SUNDRY NOTICES AND REPORTS ON WELLS
Do not use this form for proposals to drill or to re-enter an abandoned well. Use Form 3160-3 (APD) for such proposals.

8. Well Name and No.
Shell Federal No. 1

Fasken Oil and Ranch, Ltd. proposes to recomplete the Shell Federal No.1 from the Cemetery; Morrow (Gas) Pool to an Atoka zone considered by the NMOCD as a wildcat. Please see attached procedure and current and proposed wellbore diagrams for the recompletion.

Shell Fed 1
30-015-10881
Fasken Oil and Ranch, Ltd.
Conditions of Approval

Proposed Atoka Recompletion

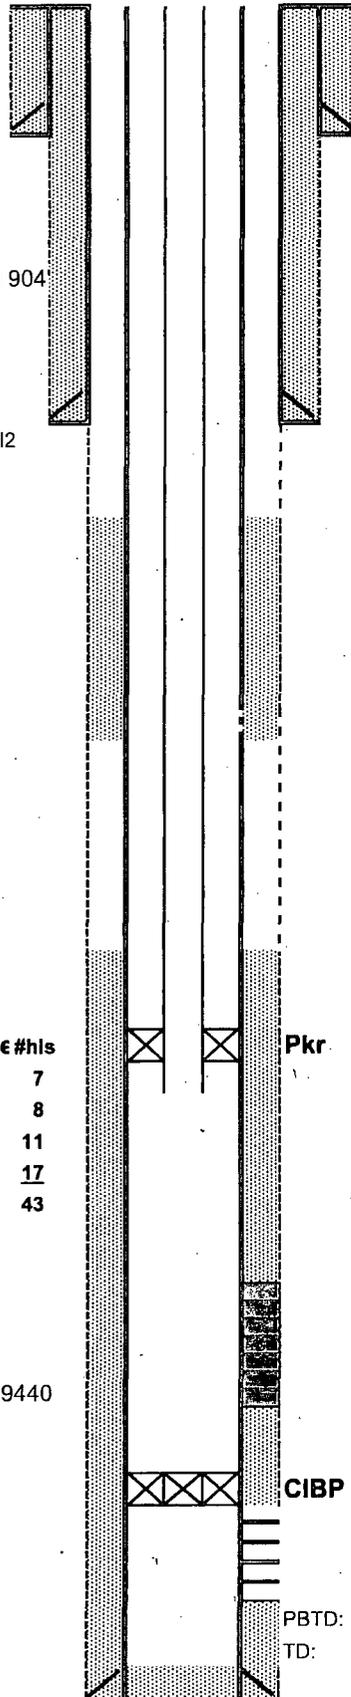
- 1. Operator shall set a CIBP at 9560' and dump 35 feet. of Class H cement. Tag required. The top of the Morrow is at 9440' and must be covered with a 200' plug prior to placing a plug over the Atoka.**

- 2. Must conduct a casing integrity test before perforating and fracturing. Submit results to BLM. Notify BLM if test fails.**
- 3. If CIT passes, recompletion is approved as written.**
